121 Heol-Cae-Gurwen, Gwaun-Cae-Gurwen, Ammanford, SA18 1PD

Further to our recent correspondence and receipt of the consultee responses, please find below our responses to the comments received in relation to application ref. P2026/0420, and all residual issues.

Revised Site Layout

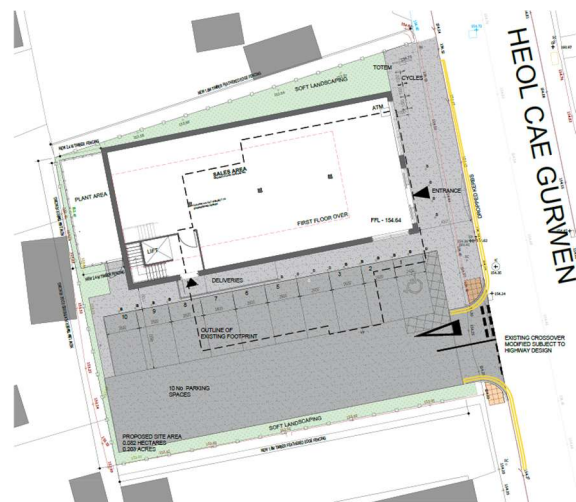
From the outset, it is important to note that, following receipt of the consultee responses, the proposed site layout has been revised to address the comments received. For ease of reference, the originally submitted site layout and the revised layout are presented below.

The changes and revisions to the site layout (and scheme generally) are set out and explained in this submission, albeit (in summary) include and contain changes to the delivery arrangements to the site, whilst attending to any inconsistency in visibility splays etc.

In relation to the proposed on-street loading bay, and as set out above in respect to the on-street parking concerns, (and with reference to the revised site layout plan submitted and included at the beginning of this note), this element has since been removed and replaced with double yellow lines along the frontage of the development. This amendment has been made to address concerns regarding potential operational efficiency of the road network.

Accordingly, it is considered that the omission of the loading bay and its replacement with double yellow lines represents the most appropriate arrangement for servicing the site.

To avoid any confusion and inconsistency between plans and outputs, the visibility splays have been removed from the revised site layout plan. This does not alter the proposed access arrangements, given that the required visibility splays of 2.4m x 90m can and will still be achieved – in accordance with, and as documented within the submitted Transport Statement.

On Street Parking effects

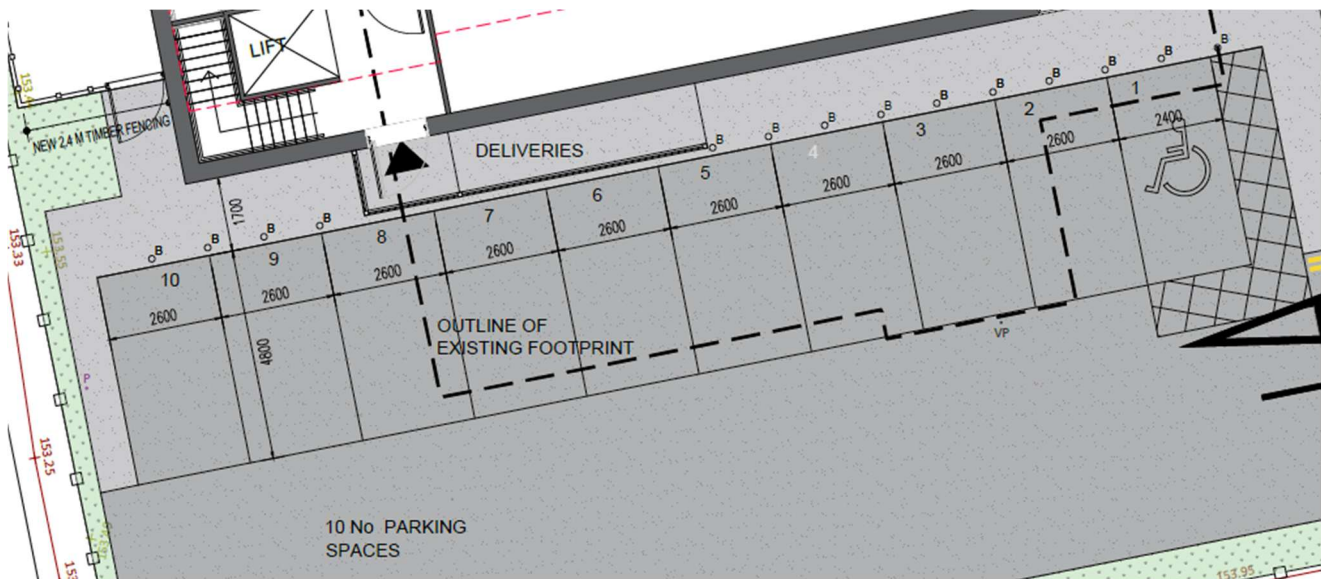
- The submitted proposal provides only ten parking spaces, resulting in a significant shortfall against the adopted parking standards;
- Insufficient evidence has been provided to demonstrate that the parking shortfall can be accommodated without adverse impacts on the operation and safety of the highway network;
- The minimum parking bay dimensions shall be 4.8 metres by 2.6 metres, and the submitted layout should clearly demonstrate compliance with these standards;
- Concerns are raised regarding the proposed on-street loading bay;
- The submitted Transport Statement states that visibility splays of 2.4 metres x 90 metres can be achieved. However, the Proposed Site Plan identifies a visibility splay of 2.5 metres x 25 metres (20mph), resulting in a discrepancy between the submitted documents.

Any overspill parking associated with the development, which in any event is considered unlikely given the scale and number of car parking on-site spaces proposed as a part of the proposal, can be adequately accommodated within the highway.

The Transport Statement prepared and submitted records that on-street parking levels are light. Given this, it is considered that there can be no assertion that the proposal would exacerbate existing parking and traffic management issues, leading to increased obstruction of the highway and reduced operational efficiency of the road network. There are no evidenced existing parking and traffic management issues, whilst any on street parking that might take place would not obstruct the highway and reduce its operational efficiency.

Double yellow lines are proposed along the site frontage – to ensure that no on-street parking hinders access to and from the site, and / or impedes on street deliveries (when undertaken). The double yellow lines are proposed in lieu of the previously proposed on-street delivery bay, and will work and function effectively and safely – much in the same way as all commercial premises along the road corridor function (and for that matter home deliveries – both food shopping and postal deliveries to residential properties).

Visuals

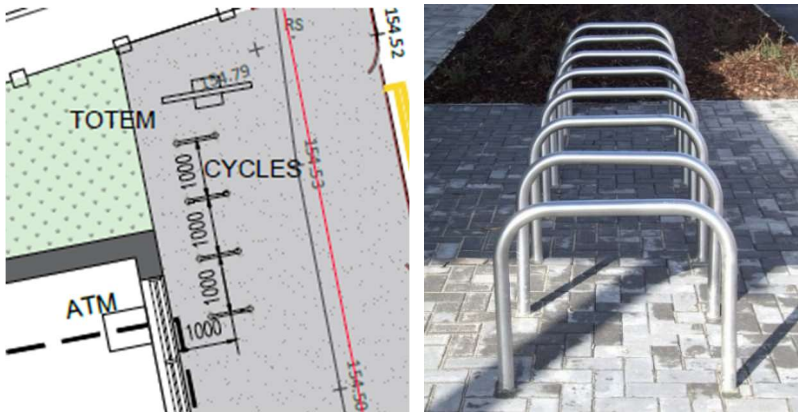
- limited information has been provided regarding how the development will physically connect to, support or safeguard the active travel routes. The applicant should demonstrate how the site layout and frontage design can facilitate future integration with the proposed ATNM route identified adjacent to the site and ensure that opportunities for future active travel improvements are not prejudiced, and that safe, direct and accessible pedestrian routes are provided between the development and bus stops to encourage sustainable multimodal journeys and reduce reliance on the private car are achievable;

The below visuals demonstrate how the proposal would interact with the existing footway connections at the site frontage – providing level, convenient, legible, useable and inviting access to and from the proposed store:

Cycle Parking Location & Example provision

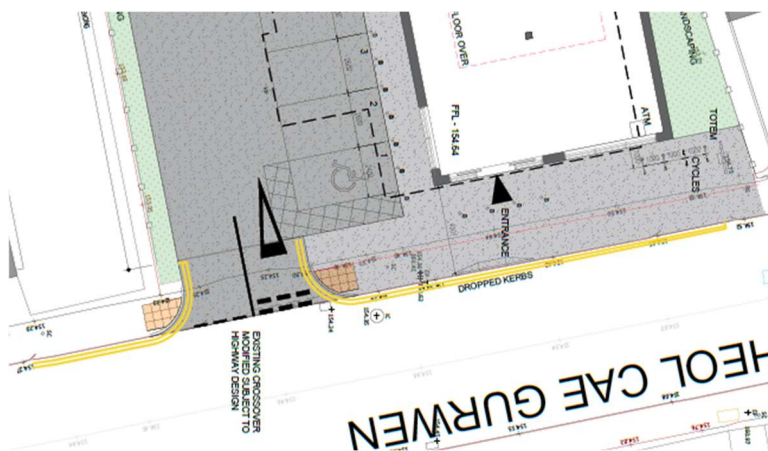
- cycle parking is proposed as part of the development; however, there is inconsistency across the submitted documents regarding the quantity and arrangement of cycle parking provision. Clarification should therefore be provided;

In regard to cycle parking, 4 no. cycle stands are proposed, providing space for up to 8 bicycles and therefore meeting the requirements of the Active Travel Act Guidance. Whilst the exact specification of the cycle storage has not yet been finalised, this detail can be secured by condition to ensure compliance.

For ease of reference, the revised plan and an example of a suitable cycle stand that will be implemented has been provided as follows.

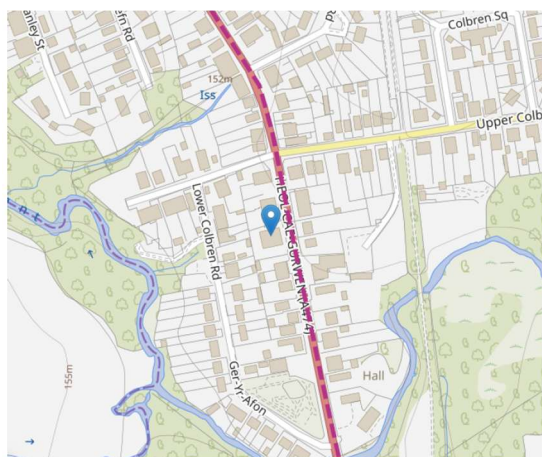
2.1 The Councils Active Travel Network Map (ATNM) shows a future route (dotted lines) in the vicinity of the proposed development.

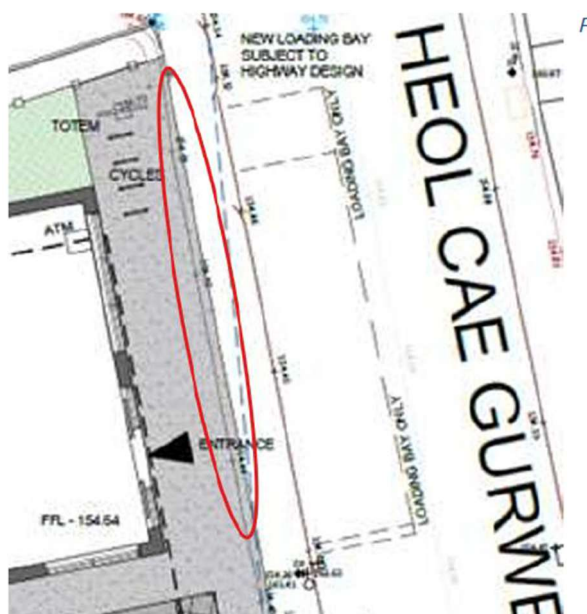
4.1. Any footways within the site should be a minimum of 2m wide, continuous, and link all entrances, parking areas and outdoor spaces. Based on the documentation provided it is unclear whether this is the case. Within the attachments there is no proposed site plan, however there is reference to one within the GJP Planning Statement June 2026 document (Screenshot attached below).

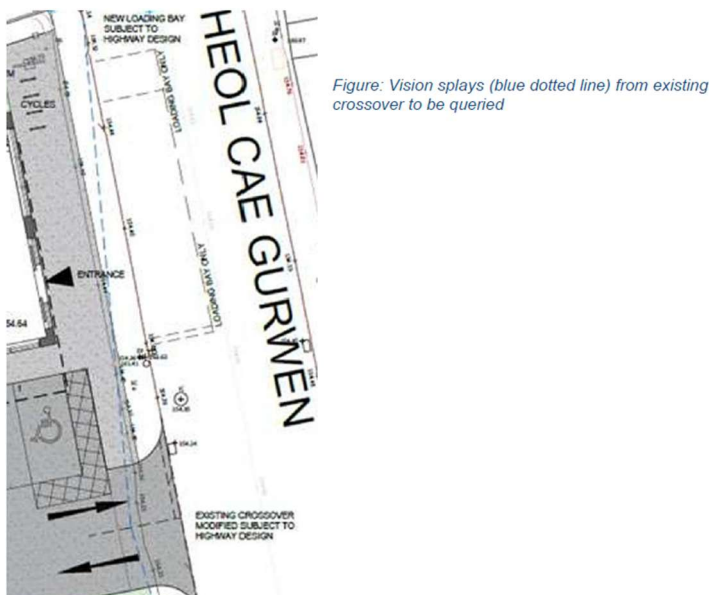
4.3, Please provide a detailed General Arrangement Plan (or similar) for the proposed development. This should include:

- Footway and carriageway dimensions;
- Parking bay dimensions;
- Cycle parking details (location, type, and capacity)
- Gradients of pedestrian routes and access points.
- Loading Bay and delivery details – i.e. are there dropped kerbs from the footway to the loading Bay, when would deliveries likely occur as this would affect visibility and usage of cycle parking/walking routes, is there consideration for how the loading Bay may limit visibility within vision splays from the existing crossover
